**SAN ANTONIO WATER SYSTEM  
PRESSURE REDUCING VALVE (PRV) FLOW MONITORING  
AND PRESSURE MONITORING PROJECT  
SAWS PROJECT NO. 09-6005  
SOLICITATION NO. B-10-056-DG  
ADDENDUM NO. 1**

**October 1, 2010**

The purpose of this addendum is to issue modifications to the plans and specifications, replies to submitted questions and responses, clarifications, and questions/comments at the mandatory pre-bid & site visit for the Pressure Reducing Valve (PRV) Flow Monitoring and Pressure Monitoring project (Saws Job No. 09-6005).

**C22**

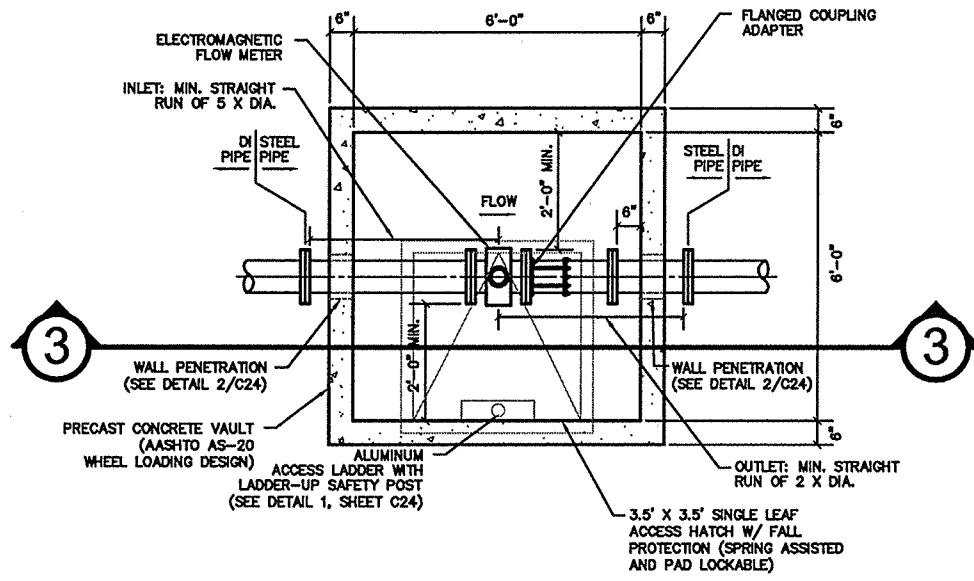
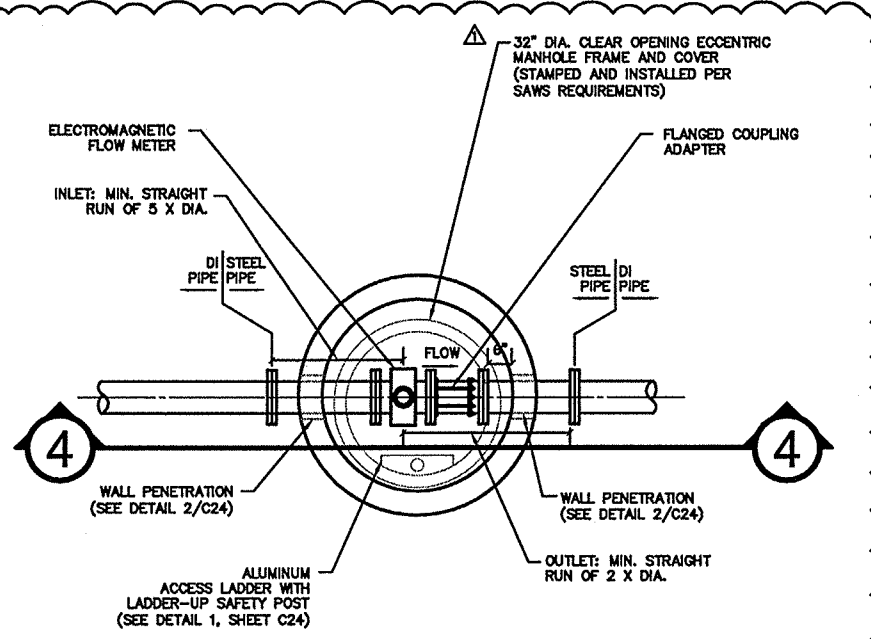
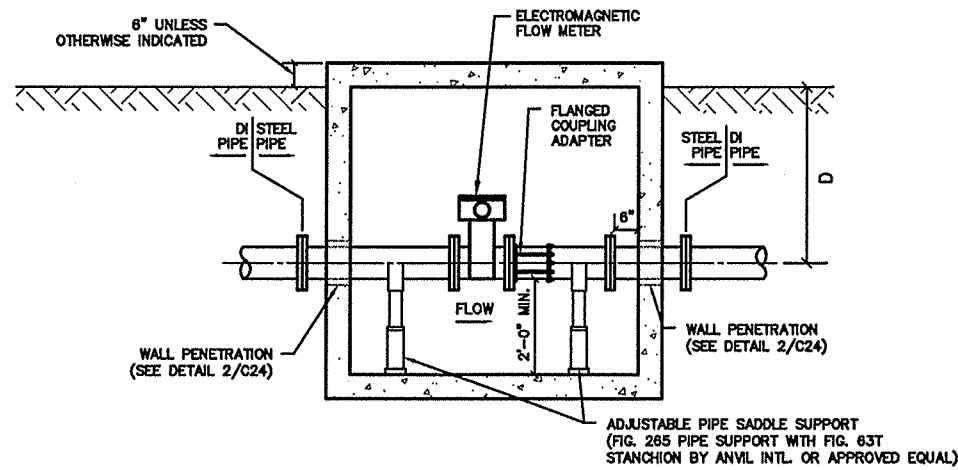
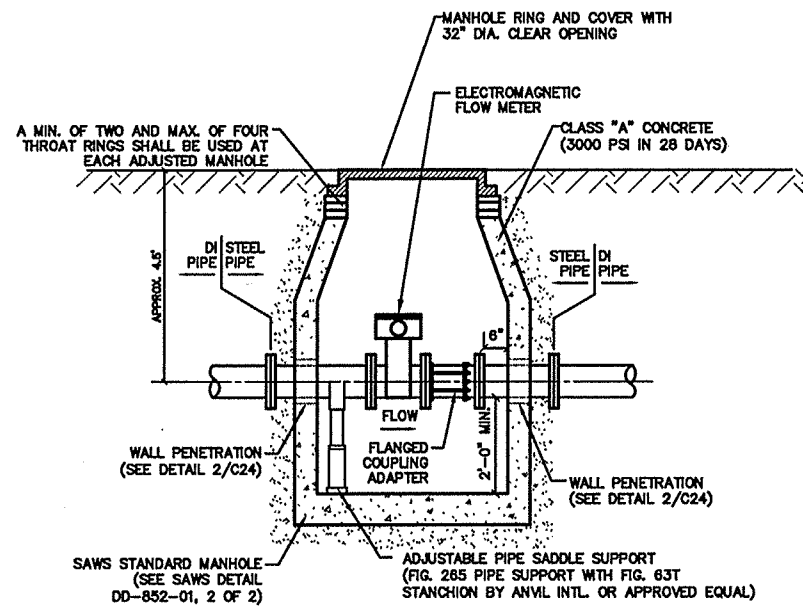
“Remove any remaining debris, replace asphalt pavement, curb, and brick pavers, and sod all remaining disturbed areas per Technical Specifications and Details. New brick pavers shall match existing.”
- E. Sheet C22 – REPLACE this sheet with the modified Sheet C22 included in this Addendum.
- F. Sheet E4B – ADD this plan sheet to the Contract Documents.
- G. Sheet E6 – REPLACE this sheet with the modified Sheet E6 included in this Addendum.
- H. Sheet E6A – ADD this plan sheet to the Contract Documents.
- I. Sheet E8 – REPLACE this sheet with the modified Sheet E8 included in this Addendum.

Q5: DD-852-02 – is vented 24" R&C, The drawing and description look like a watertight 32" R&C what diameter ring and cover is required?

MANHOLE DIA. REVISED TO 32"

Response: Revised Sheet C22 is included in this Addendum. A manhole ring and cover assembly with a 32-inch clear opening is required.
